ATTACHMENT B

Additional Documents

PLANNING COMMENTS | CARMEN DIAZ, FITZ MURPHY, DEANDREA MOISE | 07/08/2021

Re: *Planning Comments*

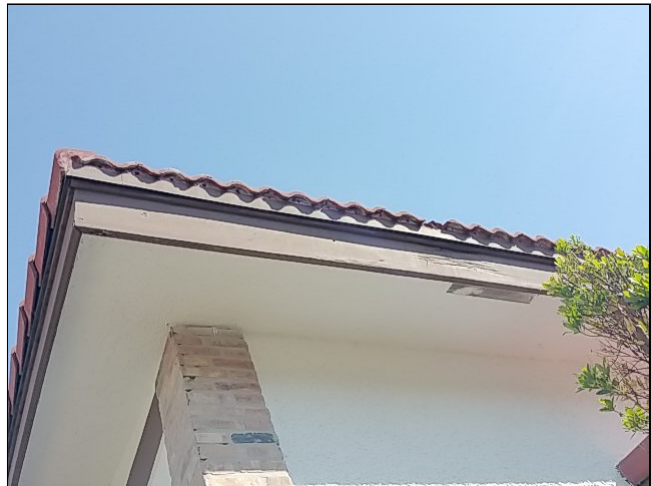
(1) Fascia has termite and wood rot damage in various areas.

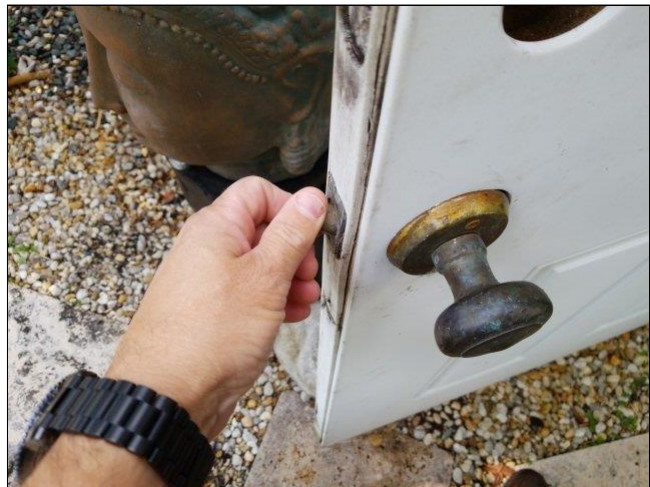
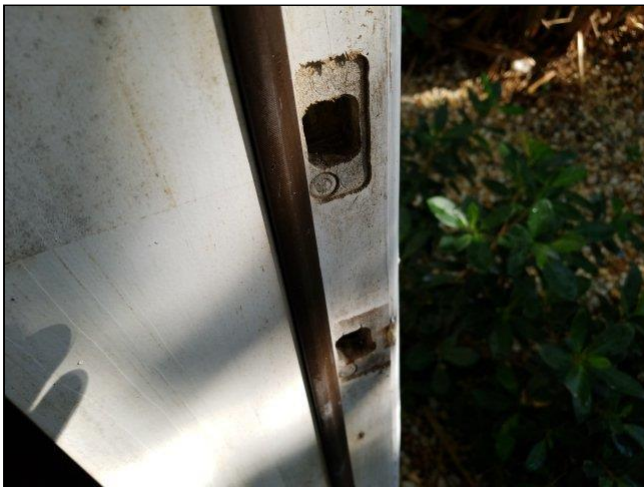
(2) Storage door has water damage, door knob assembly is inoperative and door frame is missing latch plates. Recommend replacing door and frame. \$300 to \$400

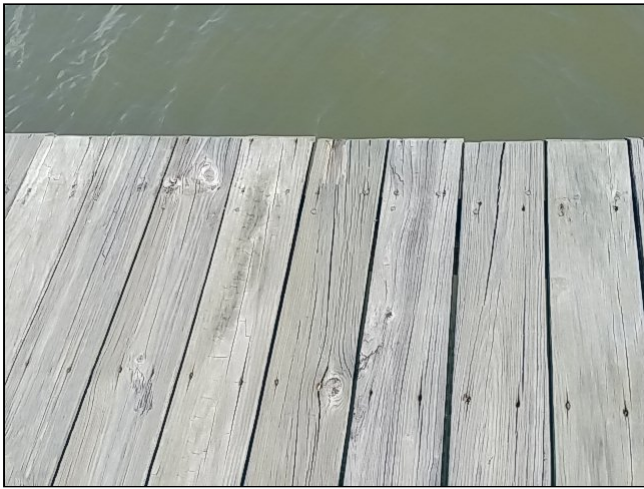
(7) Pool pump shed light fixture is inoperative. Recommend replacing fixture. \$30 to \$50

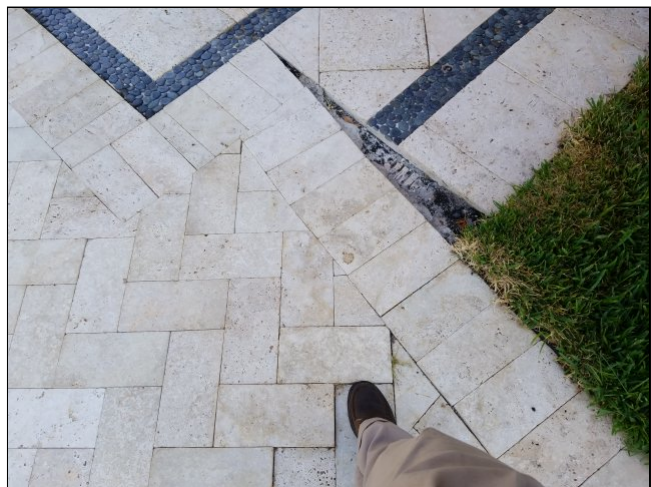
(12) Hose bib leaks when valve is open. Recommend a licensed plumber repair. \$100 to \$120

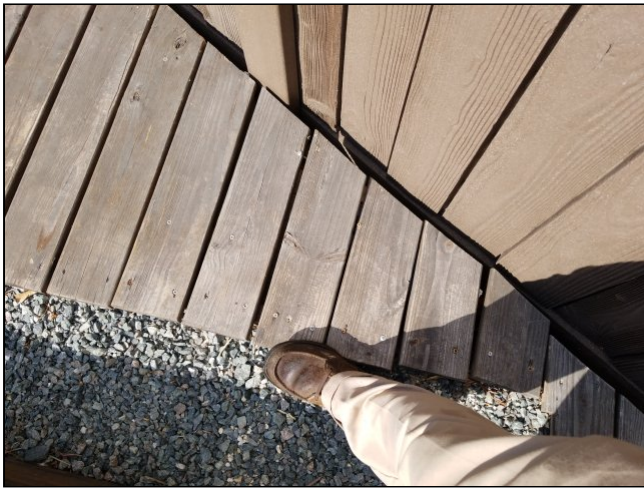
(16) Wood deck by jacuzzi has various loose boards. Recommend securing boards.

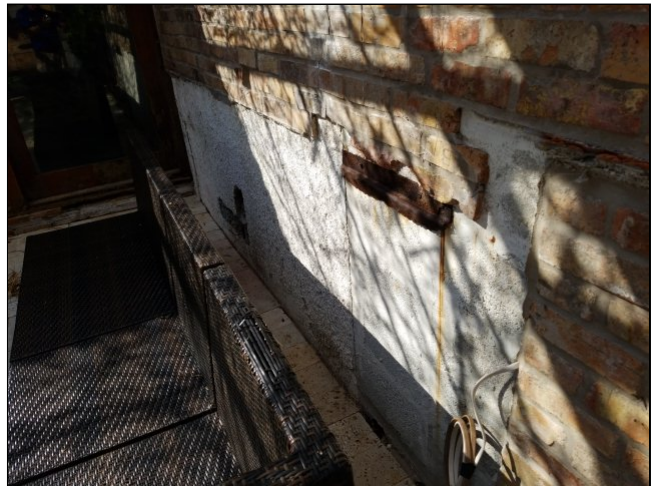
(17) Parapet wall has a settlement crack. Recommended license contractor inspect further. \$Unknown

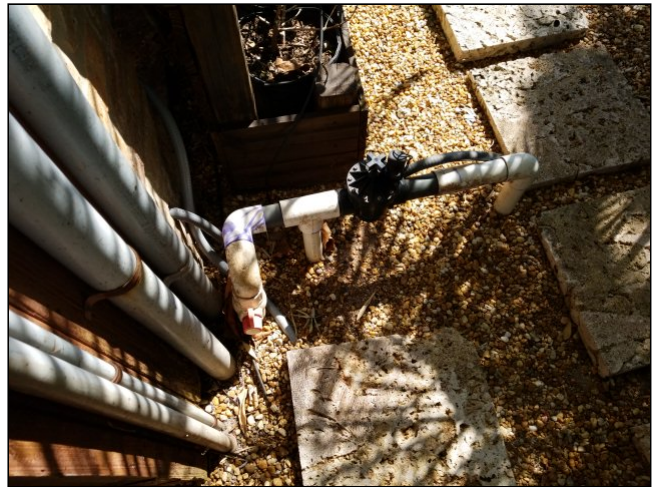
Water heater housing is rusted. No evidence of moisture at time of inspection.

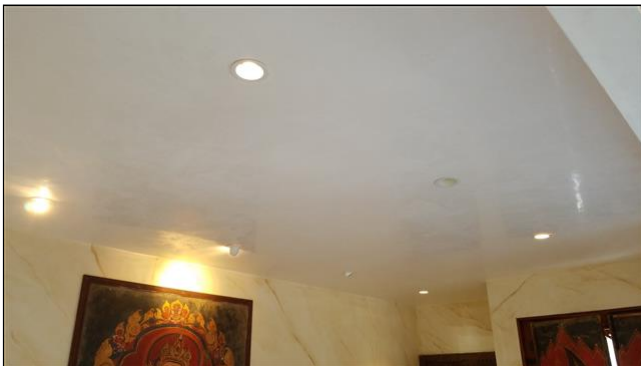
(1) Evidence of water intrusion / dry rot at window base. \$ unknown. Recommend further evaluation.

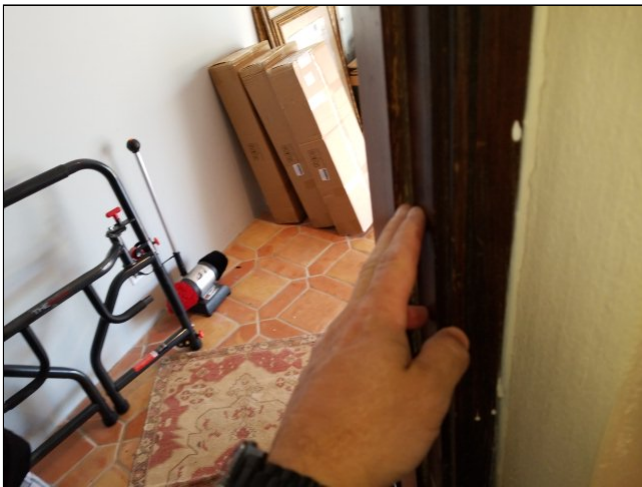
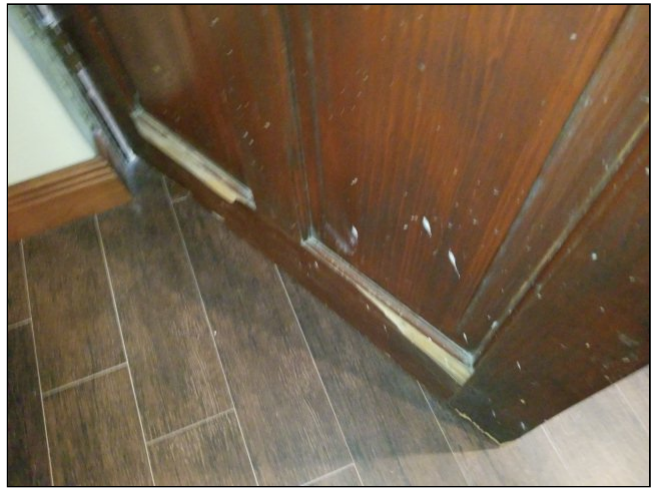
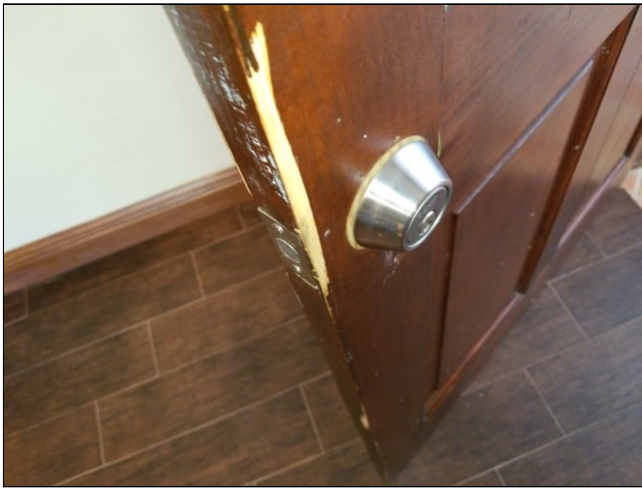
(1) Door to garage wood veneer is peeling.

(2) Various ceiling light fixtures are inoperative.
